**SYDNEY NORTH PLANNING PANEL
COUNCIL ASSESSMENT REPORT**

Panel Reference	2018SNH052
DA Number	DA2018/1514
LGA	Northern Beaches Council
Proposed Development	Major additions to the Warringah Mall Shopping Centre, including new retail premises, food premises, kiosks, department stores and a new cinema complex with associated car parking and landscaping
Street Address	Lot 100, DP 1015283, No. 145 Old Pittwater Road, Brookvale
Applicant	Scentre Management Ltd
Owner	AMP Warringah Mall Pty Ltd Scentre Management Ltd
Date of DA lodgement	12 September 2018
Number of Submissions	Two (2) submissions received in opposition to the proposal
Recommendation	APPROVAL (subject to conditions)
Regional Development Criteria (Schedule 7 of the SEPP) State and Regional Development) 2011	Development with a Capital Investment Value (CIV) of more than \$30 million Total Cost of the Development is \$226,459,908
List of all relevant s4.15(1)(a) matters	<ul style="list-style-type: none"> • Environmental Planning and Assessment Act 1979 • Environmental Planning and Assessment Regulation 2000 • State Environmental Planning Policy No. 55 – Remediation of Land • State Environmental Planning Policy – Infrastructu

Figure 7 – Setback non-compliance on Level 1 **Figure 8 – Setback non-compliance on Level 2**
(Area of non-compliance is hatched in red, source from Statement of Environmental Effects, papered by Urbis).

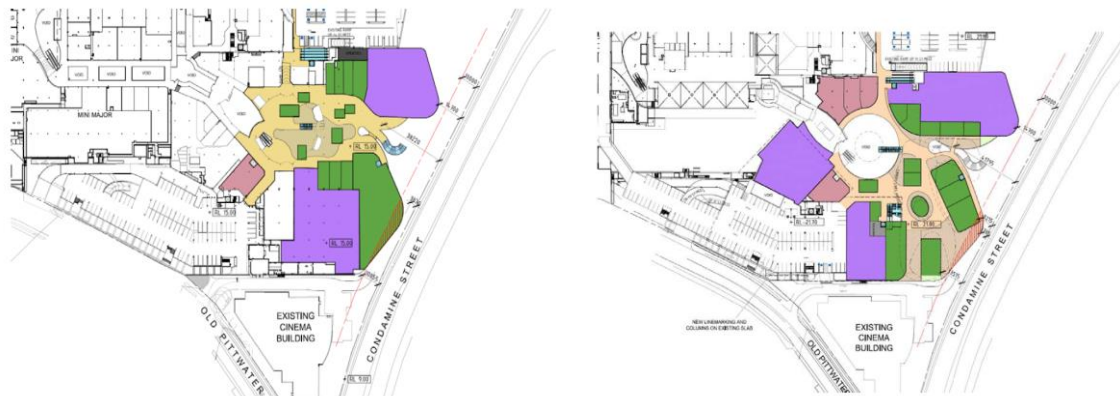
The non-compliant element relates to a projecting portion of the building adjacent to the southern pedestrian entrance. The extent of non-compliance is shown in Figure 7 as it relates to non-compliance on Level 1 and Figure 8 as it relates to Level 2 below:

The proposed works include various finishes and materials to provide visual and streetscape interest and allows for appropriate landscape works to be undertaken both within the site and within the road reserve. The proposed setbacks will have a negligible impact on adjoining properties in respect to shadow impact, amenity or privacy and are appropriate to the scale of the development.

Figure 9 – Proposed Roof Plan (with RL's showing the proposed RL's in black and the required DCP RL's in red) (Source: Scentre Design and Construction Pty Ltd)

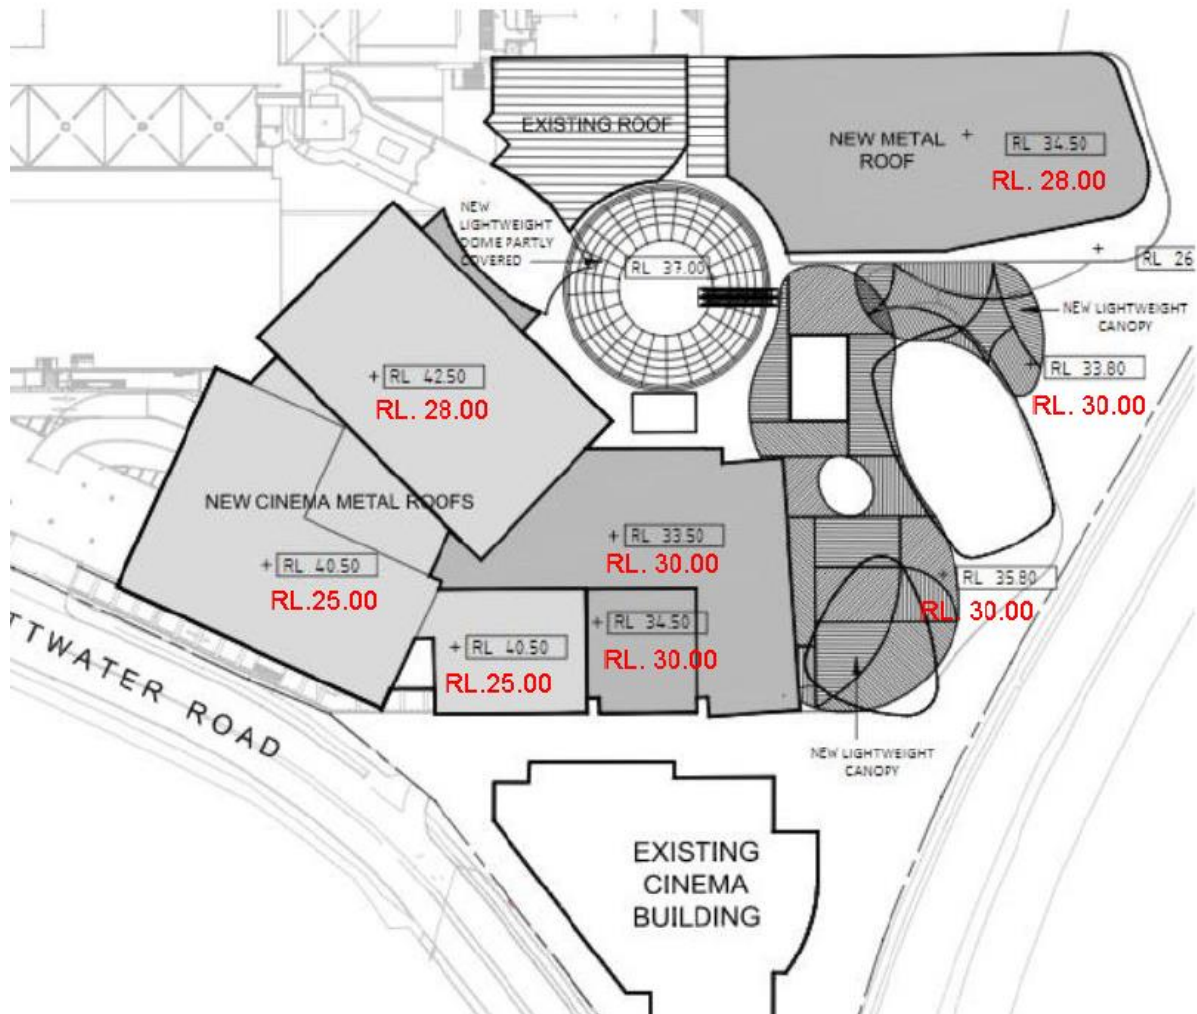
Part G4 Warringah Mall of Warringah DCP 2011 contains controls relating to building height. The controls stipulate maximum building heights across the site by way of a building envelope plan. The building envelope plan shows a maximum of RL30 for development in the southern corner of the site and a maximum of RL25 for development along a portion of the Old Pittwater Road frontage.

- Maximum RL40.50 as it addresses Old Pittwater Road
- Maximum RL42.50 at the centre of the proposed cinema complex
- Maximum RL34.50 and RL40.50 at the east of the proposed building

The breach to the height is calculated to be 15.5m and 14.5m respectively.
